Brian Cunningham  
Stony Hill Farm LLC  
899 Stony Hill Rd.  
Wilbraham MA 01095

February 23, 2018

**Re: Comments on Agricultural Solar Tariff Generation Unit Guidelines**

## Appendix A

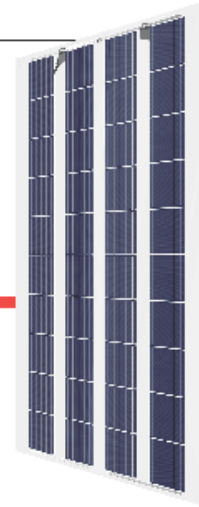
<sup>1</sup> Note that these bracing supports may also undermine the intended purpose of the eight foot requirement of allowing for mechanical cultivation under the solar array. See appendix A for an agriculture installation photo with bottom edge of the modules at 8’ but diagonal bracing at 6’ above grade, potentially negating the benefit from the additional height gained.
